SIB 11 10 21

RECALL 21V-907: EXHAUST GAS RECIRCULATION (EGR) COOLER – N57T LOW TEMPERATURE

This Service Information Bulletin (Revision 3) replaces SI B11 10 21 **dated October 2022**.

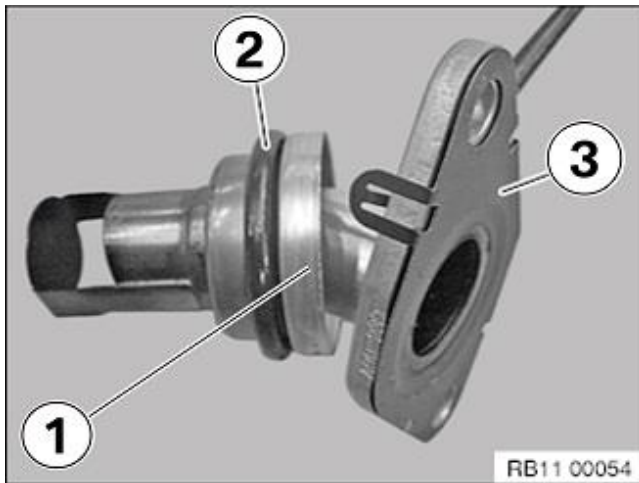
- When the old EGR cooler is removed:

- Remove the EGR pipe from the intake venturi pipe (replace O-ring (2) and gasket (3)).

- Inspect and clean (if needed) the EGR pipe. Wear protective equipment (eyes and hands) and clean out the excessive carbon using a degreasing agent and a brush (suitable brushes can be found in wheel brush kit 83 19 2 298 237).
- Reinstall the EGR pipe with new gasket and O-ring before installing the new EGR cooler.

- Replace the coolant pipe from the Auxiliary EGR cooler to the coolant pump distribution block (1)

- NOTE: The new coolant line PN 11 14 7 827 410 is routed in a different location than the original line (1)
